Proposal for Corrigendum to Regulation No. 48

Submitted by the Chair of the task force on conspicuity marking of the Working Party on Lighting and Light-Signalling. The text reproduced below was prepared by the experts of the task force on "Conspicuity Marking" of the Working Party on Lighting and Light-Signalling (GRE), by discussing the question on marking of the cab of a motor vehicle, as agreed during the sixty-sixth session of GRE (see ECE/TRANS/WP.29/GRE/66 para. 7). The modifications to the existing text of the Regulation are marked in bold for new or strikethrough for deleted characters.

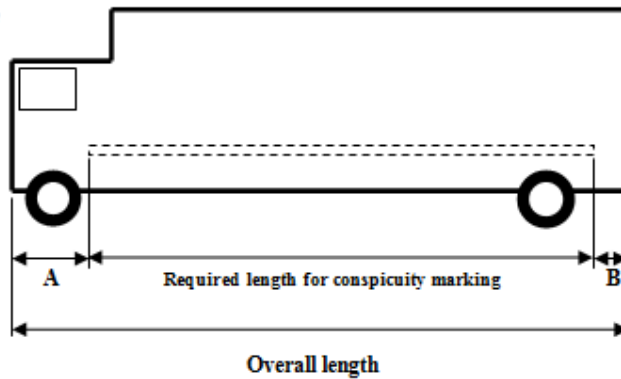
6.21.4.2.2.1. for motor vehicles, ~~length of the~~ **required length for conspicuity marking of a motor vehicle** ~~vehicle excluding the cab~~, or in the case of tractors for semi-trailers, if fitted, the length of the cab;

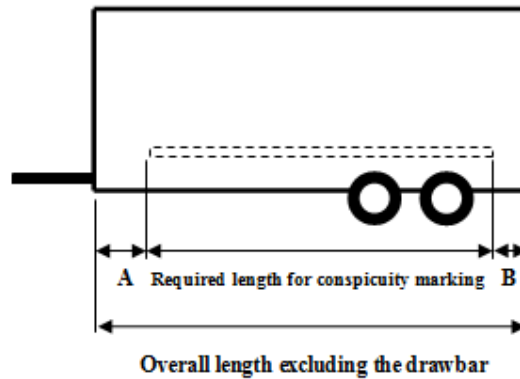
6.21.4.2.2.3. The required length for conspicuity marking shall be determined as follows (see also figure below):

- For a motor vehicle, the overall length of the vehicle minus the unmarked end and minus the unmarked front;
- For a trailer, the overall length of the vehicle excluding the drawbar minus the unmarked end and minus the unmarked front.

A = "unmarked front", is the distance between the foremost conspicuity marking and the front end of the vehicle (in case of trailers excluding the drawbar). The maximum value of **A** is 600 mm (see paragraph 6.21.4.2.1.), or alternatively [1800] mm for motor vehicles (see paragraph 6.21.4.2.1.1.).

B = "unmarked end", is the distance between the rearmost conspicuity marking and the rear end of the vehicle. The maximum value of **B** is 600 mm (see paragraph 6.21.4.2.1.).
